**AGENDA
TOWN OF PITTSFORD
PLANNING BOARD
FEBRUARY 9, 2026**

DDS Engineering and Surveying, LLP, Kirik Subdivision
Preliminary/Final Subdivision

Re: **2118 W Jefferson Rd – Subdivision and Single Family Home**

The following letter has been written in response to comments received from the Town of Pittsford Development Review Committee dated 1/8/26. All comments have been addressed below.

TYPICAL SANITARY LATERAL TRENCH DETAIL

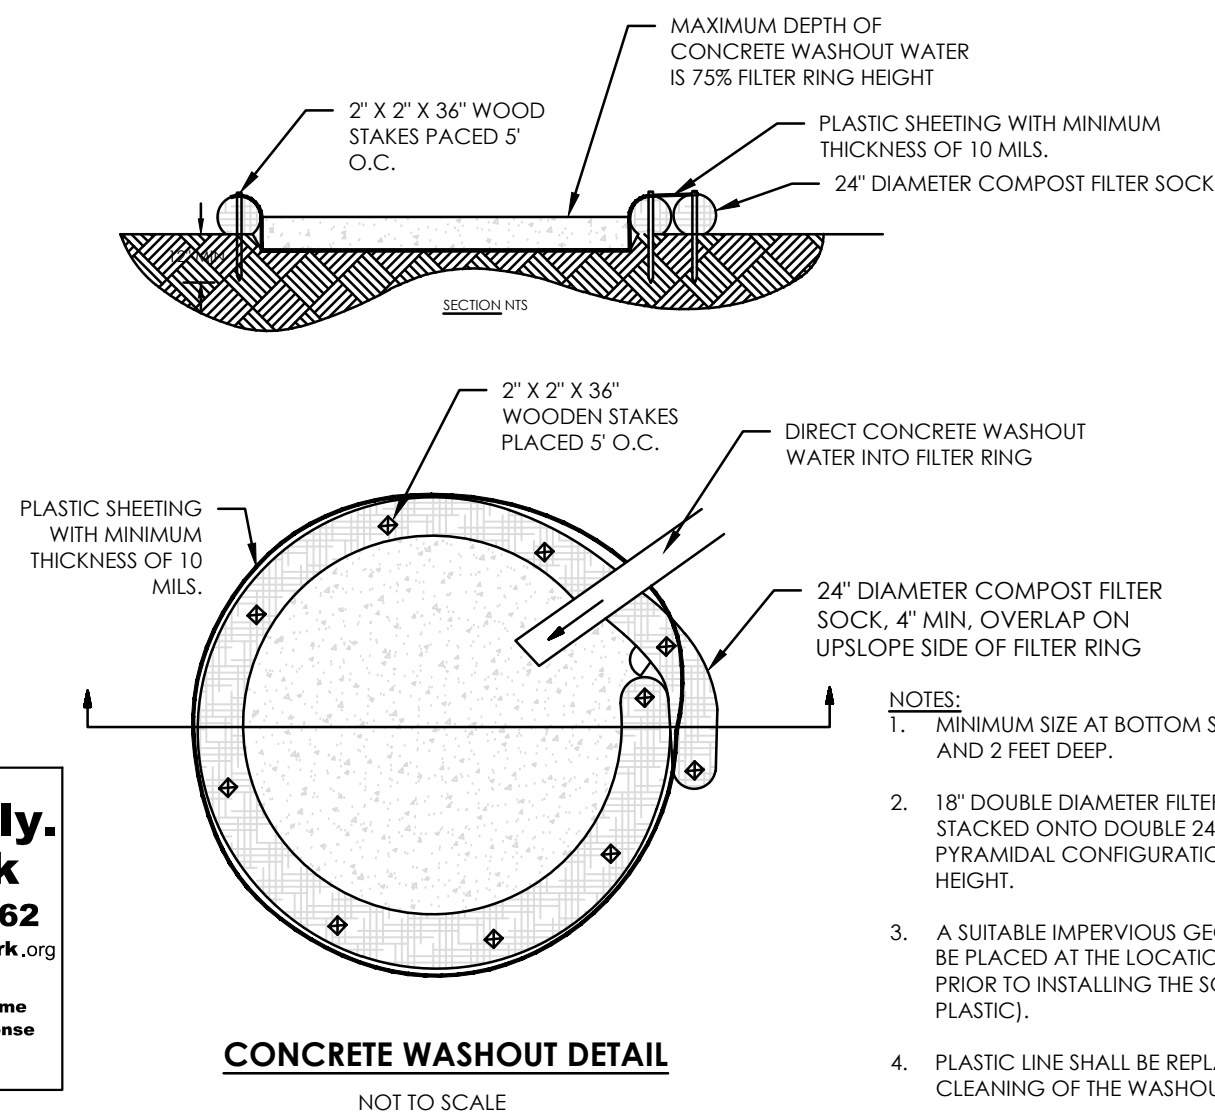
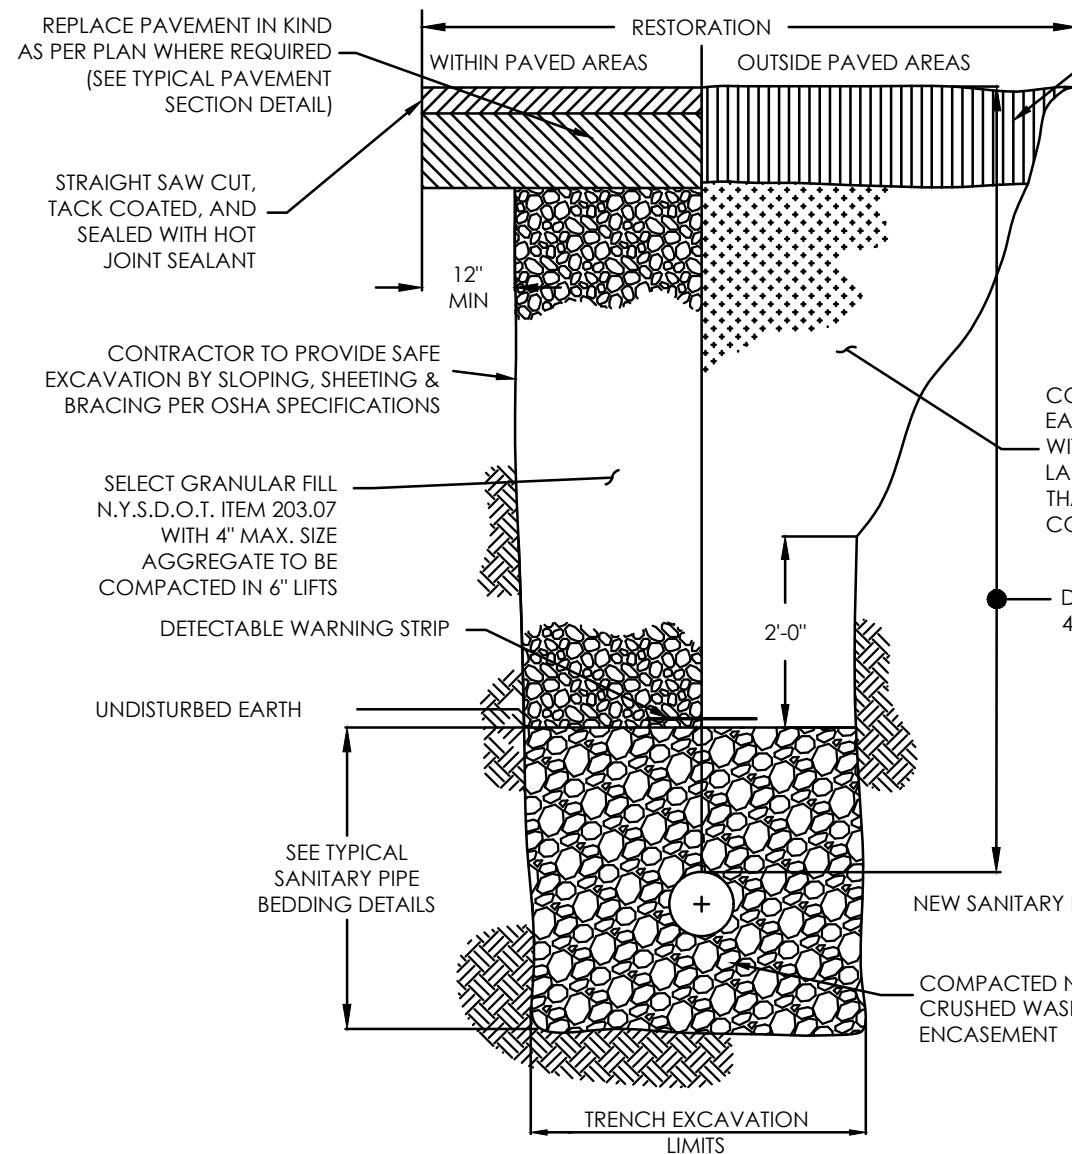
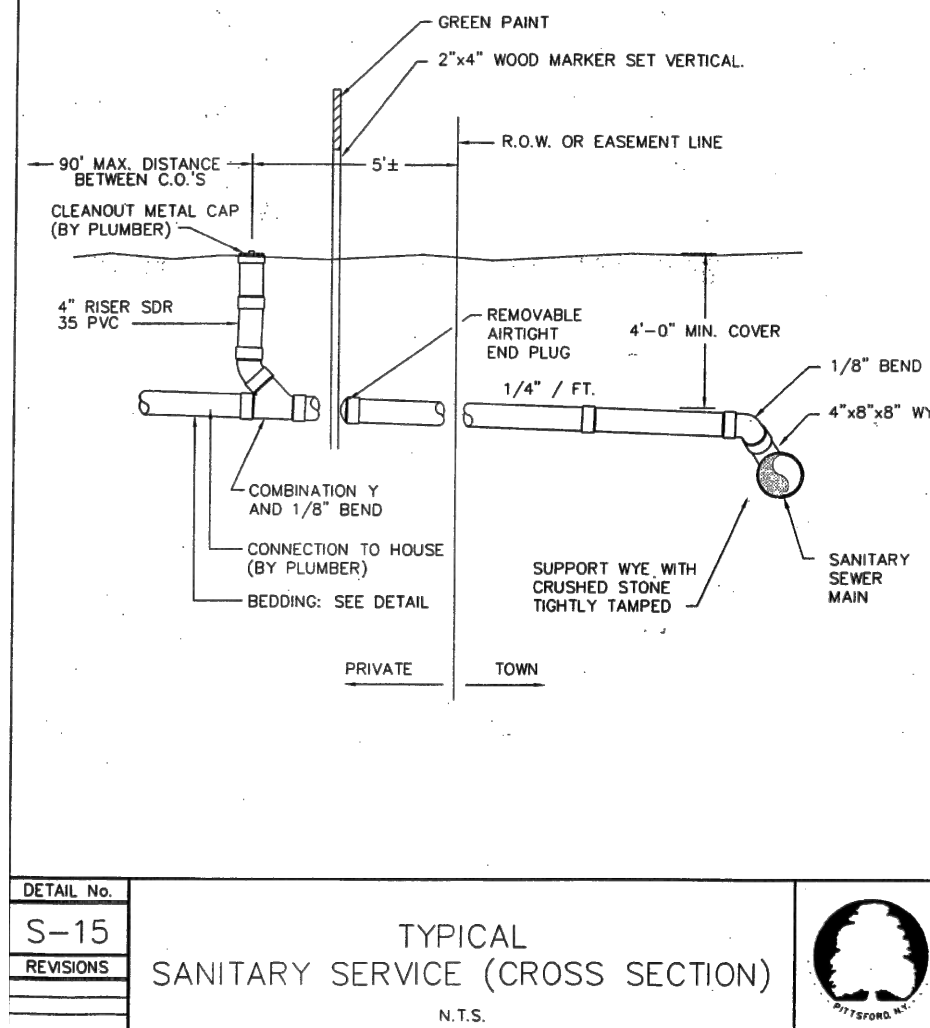
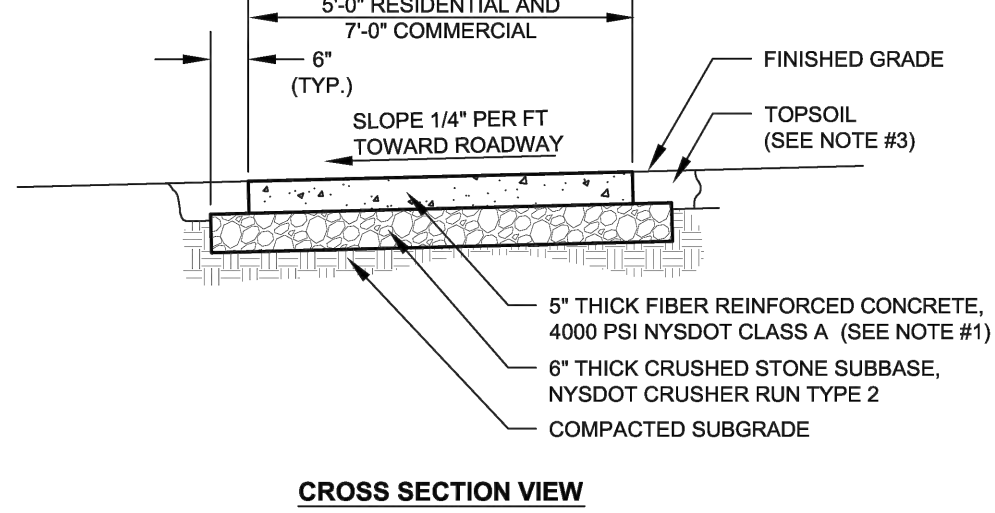
15. Please provide the standard Town of Pittsford sanitary lateral detail and trench detail. (TRE)

Sanitary lateral detail and trench detail have been added to plans.

CONCRETE SIDEWALK DETAIL

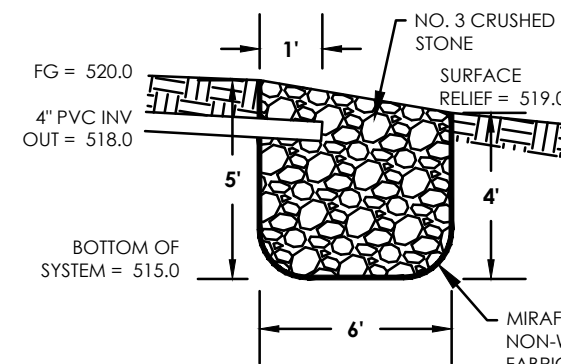
7. The Planning Board and Town's Comprehensive Plan supports planning for and creating walkable communities. Sidewalks and trails are considered with all developments in town and the Board works towards making connections where possible. Please include a 15-foot-wide sidewalk easement along the W. Jefferson Road frontage and a 5-foot sidewalk within the easement. Town of Pittsford sidewalk details should be provided within the plan set. (DPW, TRE)

5-foot sidewalk has been shown on plans. Sidewalk details have been added to site plan.

STONE-FILLED DRY WELL

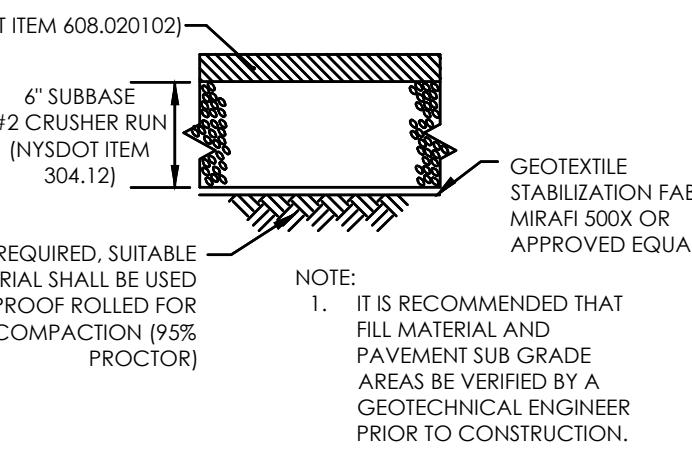
17. Please provide details associated with the sump pump discharge. It is recommended that this drainage is directed to a drywell. (DPW)

Sump pump discharge has been revised to a stone filled dry well, as suggested/ requested in correspondence with Doug DeRue on 1/28/26. Detail has been provided on sheet C2.
